Access Compliance Report

Public Rights-of-Way

(Curb Ramps)

Intersection ID: 10024261	Main Street: CRAIG_AV	Cross Street: N/A	Location: NW
ADA ID: BD5D5ACCC441	Ramp Type: PerpDiag	Initial Pass/Fail: Fail	Overall Compliance: No
Severity Score: 21.25			
Codes/Mitigation Info/Possible Solution		Field Measurements/Component Compliance

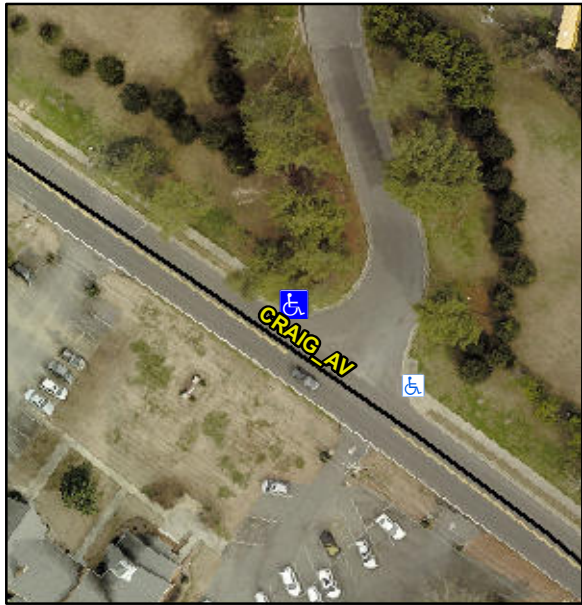
Not Found, R304.5.1, R304.2.2

Compliance	Description	Data	Compliance	Description	Data
N/A	Ramp Length (in)	72.0	No	Ramp Slope (%)	8.9
No	Ramp Width (in)	39.0	Yes	Ramp XSlope (%)	0.5
N/A	Flare Type LT	N/A	N/A	Flare Type RT	N/A
N/A	Flare Slope LT (%)	N/A	N/A	Flare Slope RT (%)	N/A
N/A	Flare Traversable LT?	N/A	N/A	Flare Traversable RT?	N/A
N/A	Landing Length (in)	N/A	N/A	DWS Provided?	N/A
N/A	Landing Width (in)	N/A	N/A	DWS Contrast?	N/A
N/A	Landing Slope (%)	N/A	N/A	DWS Length (in)	N/A
N/A	Landing X Slope (%)	N/A	N/A	DWS Full Width?	N/A
N/A	Landing Curb? (Y/N)	N/A	N/A	DWS Offset (in)	N/A
N/A	Shared Landing?	N/A			
N/A	Gutter Ponding?	N/A	N/A	Gutter Slope (%)	N/A
N/A	Gutter Lip Ht (in)	N/A	N/A	Gutter X Slope (%)	N/A
N/A	Painted X Walk1?	No	N/A	Painted X Walk2?	No
	X Walk 1 Direction	To SW		X Walk 2 Direction	To SE
N/A	X Walk 1 Width (in)	N/A	N/A	X Walk 2 Width (in)	N/A
	X Walk 1 Slope (%)	2.5		X Walk 2 Slope (%)	2.8
	X Walk 1 X Slope (%)	2.9		X Walk 2 X Slope (%)	3.9

Remove & Replace Curb Ramp With Two New Directional Ramps or Equivalent.
